Technical Bulletin / Bollettino Tecnico

ECAM290.6x, ECAM290.8x

Date / Data: 15/12/2021

ENGLISH**Solution to avoid possible abnormal INSERT GROUNDS CONTAINER alarm on Magnifica EVO machines equipped with milk carafe**

INSERT GROUNDS CONTAINER alarm on Magnifica EVO machines

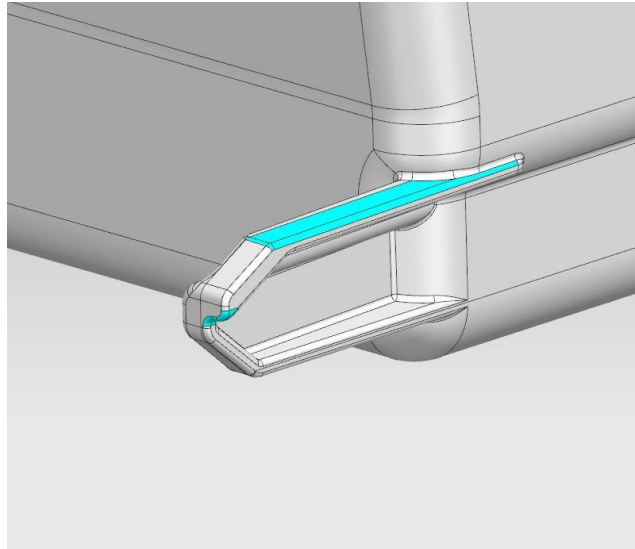
During the continuous checks to improve the products performances, we have discovered a limited number of cases in which **Magnifica EVO** machines (only versions equipped with milk carafe) could display the INSERT GROUNDS CONTAINER abnormally while the machine is delivering coffee or milk beverages:

The root cause of this fault is due to an abnormal release of the micro switch by the pin on the grounds container, because of losses of tolerances.

Grounds container pin with improved dimensions

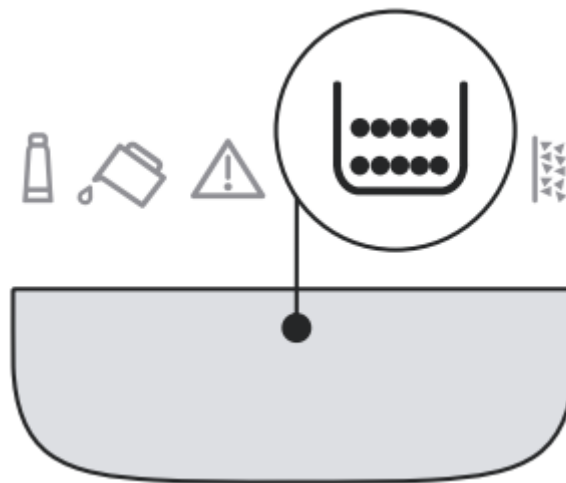
To reduce the risk of such kind of effect, the pin of the grounds container, which is responsible for the micro-switch activation, has been improved in size to make the switch engagement much more stable. The below picture shows briefly the changes of the grounds container pin sizes:

The improvement has been implemented in the manufacturing line starting from November 15th 2021.

All the grounds containers for Magnifica EVO (milk carafe versions) available in the DLS stock (part nos. **AS00002570**, **AS00002571** and **AS00002572**) are already implementing the above solution.

IMPORTANT NOTICE: As the number of cases of the above-mentioned failure is quite low, we recommend replacing the grounds container **only in case the user would complain** about abnormal appearance of the INSERT GROUNDS CONTAINER alarm.

Allarme INSERIRE CONTENITORE FONDI sulle macchine della gamma Magnifica EVO

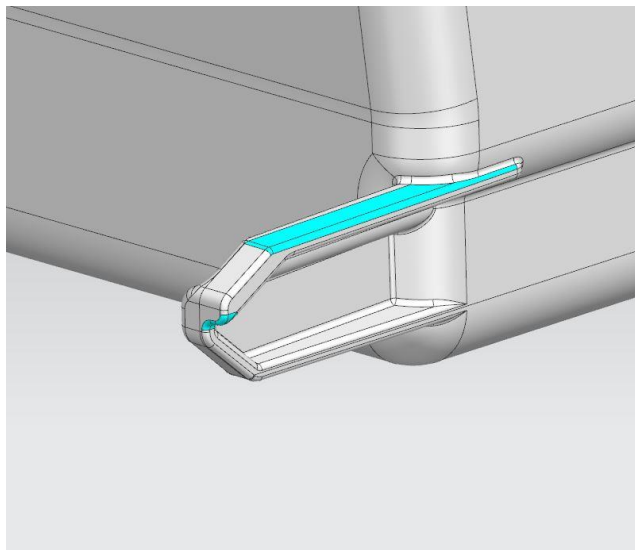
Nell'ambito dei continui controlli volti a migliorare le prestazioni dei prodotti, è stato riscontrato un numero limitato di casi in cui le macchine della gamma **Magnifica EVO** solamente nelle versioni dotate di caraffa latte potrebbero visualizzare erroneamente l'allarme INSERIRE CONTENITORE FONDI mentre la macchina sta erogando bevande a base di caffè o di latte:

La causa di questo difetto è stata individuata in un anomalo rilascio del micro interruttore da parte del dentino del contenitore fondi, a causa di una perdita di tolleranze.

Per ridurre il rischio che tale inconveniente possa verificarsi, è stato modificato il dimensionamento del dentino del cassetto fondi responsabile dell'azionamento del micro interruttore, al fine di garantire che l'ingaggio dell'interruttore rimanga stabile. La figura seguente esemplifica le modifiche dimensionali eseguite sul dentino del contenitore fondi:

L'azione migliorativa è stata implementata in produzione a partire dal 15 Novembre 2021.

Tutti i contenitori fondi per machine della gamma Magnifica EVO (versione dotata di caraffa latte) disponibili a stock DLS (codici articolo **AS00002570**, **AS00002571** e **AS00002572**) implementano già la soluzione sopra citata.
